## ARBORICULTURAL REPORT

Ref: Oak tree  
Situated on land at North Lane  
Weston on the Green  
Oxfordshire

Ref: 22036

Issued: 18<sup>th</sup> February 2022

TITLE: Draft Tree Protection Plan	
PROJECT/SITE: Footpath at Weston on the Green	
CLIENT: Firmpride Ltd	
MAP REF: 3995 / 01 / D16-1130	
REVISION: 1	
DATE: July 2016	SCALE: 1:200@A3
APPROVED BY: SW	PRODUCED BY: RD

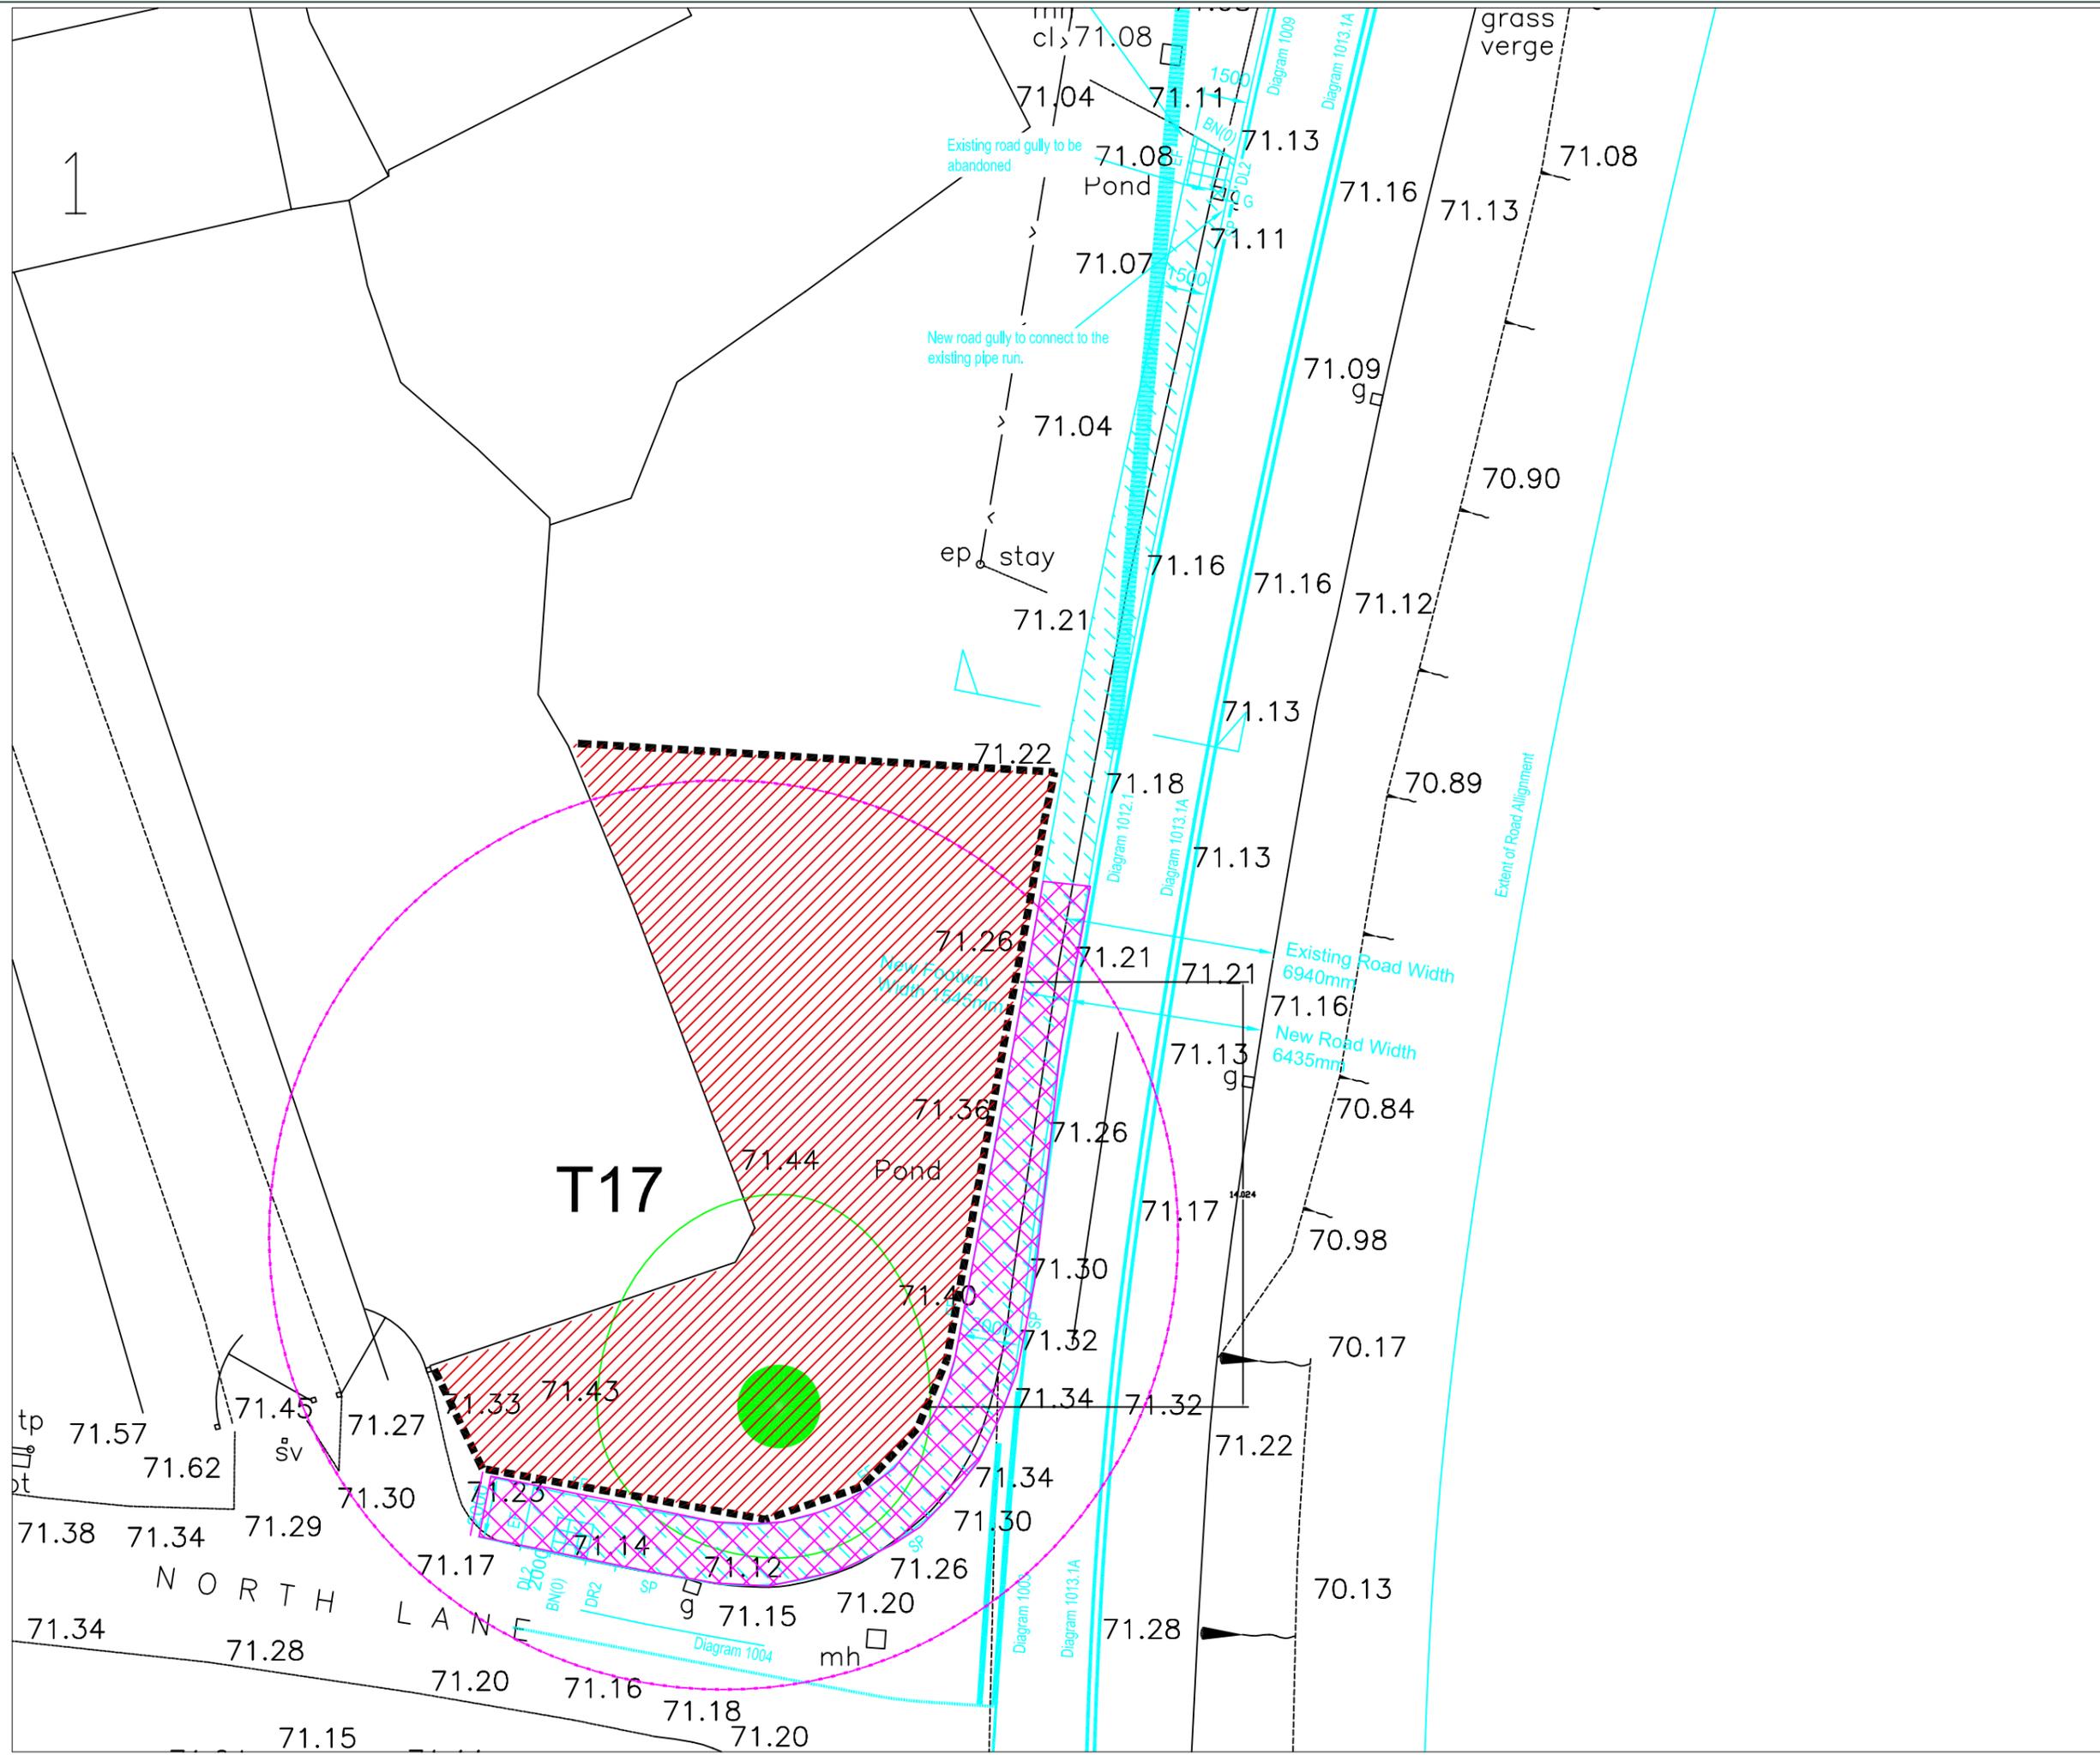
- 3.1 8 At section 3.38 of the arboricultural method statement permanent hard surfaces within the RPA 's of trees are dealt with. Specific reference is made in relation to the oak tree:

*3.38 Where permanent hard surfaces are required within the RPA, there must be no excavation into the soil, either through the lowering of levels and/or scraping, other than the removal of turf or other surface vegetation. All such works shall be carried out using hand tools only.*

*3.39. One tree (T17) will require permanent protection due to the construction of a new footpath leading from the development providing access to Weston on the Green.*

*3.40. In order to protect the RPA of T17 a three-dimensional cellular confinement system will be installed. This is a load bearing system which protects roots from the effects of compaction from regular pedestrian movement. The recommended product for this solution is CellWeb but whatever system is used, the end result must be that the underlying soil (rooting environment) remains undisturbed and retains the capacity to support existing and new roots.*

*3.41. The dimensions for the area protected by the Cellweb have been marked on the draft TPP (Ref: D16-1130), which can be identified by the purple crosshatch on the plan*

1. Gradient changes have occurred within the root protection area of the oak tree (see images at Appendix 8). Noncompliance with the Arboricultural Method Statement (AMS) issued by Lockhart Garratt dated July 2016.

2. Noncompliance with the Arboricultural Method Statement (AMS) issued by Lockhart Garratt dated July 2016 at Sections 3.38 & 3.40.
  3. No evidence that an Arboricultural Clerk of Works (ACoW) was appointment as recommended within Arboricultural Method Statement (AMS) issued by Lockhart Garratt dated July 2016.

- 4.1.6 The construction of the 'Cellweb' path is not in compliance with the manufacturers instructions and as such is deemed not fit for purpose. The subbase that has been installed in not permeable and will not allow gaseous exchange to occur for the roots or to allow water to percolate through to the rooting zone.

- 5.1 It is recommended that the path is removed and the soft ground areas re-instated to allow conditions suitable for (new) root growth to occur and for the existing rooting environment to thrive.
- 5.2 Given the nature of the work that has occurred it is strongly recommended that the oak tree is regularly inspected by a competent person. It is recommended that annual inspections occur. Inspections must also ensure that the canopy condition is monitored (visual summer inspections) and autumn inspections are also implemented. This is to review whether any decay fungus is present which could affect the trees health and or stability.
- 5.3 In the event that any fungal fruiting bodies are found on or within close proximity to tree it is recommended that these are positively identified by a competent person as soon as is practically possible.
